Date: 9/29/10

Subject: 10 CFR Part 21 report of potential issues with certain Regulator Model 77N-40

Attachment A

Figure 1

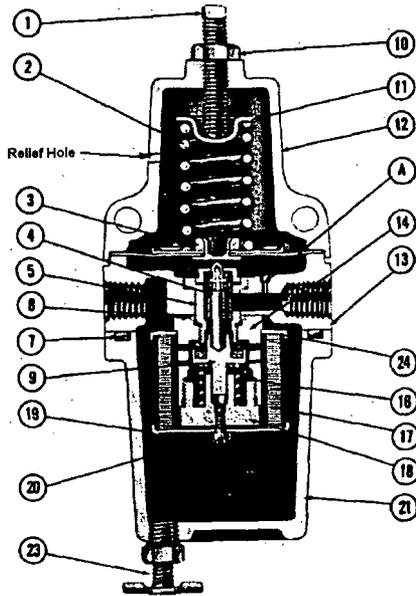
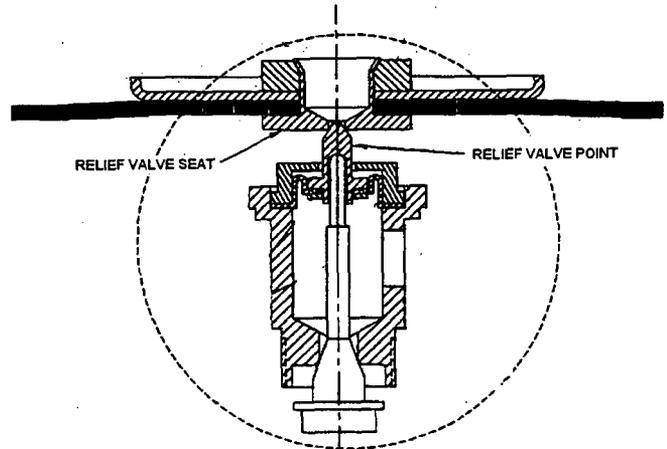
It was discovered during the evaluation process that the O-ring (#8 Figure 1) which isolates the pressure chambers can become damaged during the assembly process. A review of internal procedures found that the O-ring in question was assembled in the inverted position not visible to the technician during the process. Therefore the O-Ring had the potential to be damaged by the threads of the mating part.

It was also found that the supplier of the component referred to as the "Body" (#13 Figure 1) had not properly de-burred the bore that contained the sealing surface of the O-Ring on some components. The resulting sharp edge can be another source of potential damage to the O-ring.

The Relief Valve seat had indications of damage that were found to be caused by an assembly technique referred to as "coining". In this process, the Relief Valve point is aligned with the Relief Valve seat and using mechanical impact, the seats conform to one another to provide a tight seal. Our investigation showed that if misalignment occurred during the process the seat would sustain damage causing the sealing capabilities to quickly deteriorate in service.

The Relief Valve seat may have contained burrs. Inspections of the Relief Valve seats in our inventory indicated the supplier was not properly prepared the seating surface. Approximately 30% of the inventory contained questionable seating surfaces.

- Inspection was added to the Body bore edge in our dedication plan.
- Inspection was added to the Relief Valve seat in our dedication plan.
- Procedures and instructions were updated to ensure that the O-Ring was assembled such that the technician can visibly see the components and ensure the O-Ring is not damaged during the assembly process.
- We reviewed the use of the "coining" technique and eliminated the practice from the current process. The technician is now instructed to assemble and test the Regulator without coining. If the Regulator does not pass the required testing the Regulator will be disassembled and the relief valve components replaced until an acceptable combination passes test.
- The existing inventory was reworked to the corrective actions above.

Figure 3
Acceptable

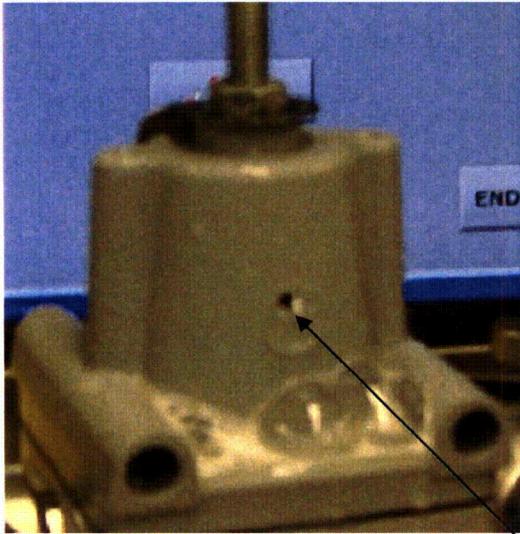
Apply leak detection fluid to the Relief hole as shown. Acceptable bubble size is shown in Figure 4. The acceptable leak rate of the bubbles is 1 to 3 per second. Unacceptable bubble size is shown in Figure 5 or bubbles that form at a rate of more than 5 or more per second.
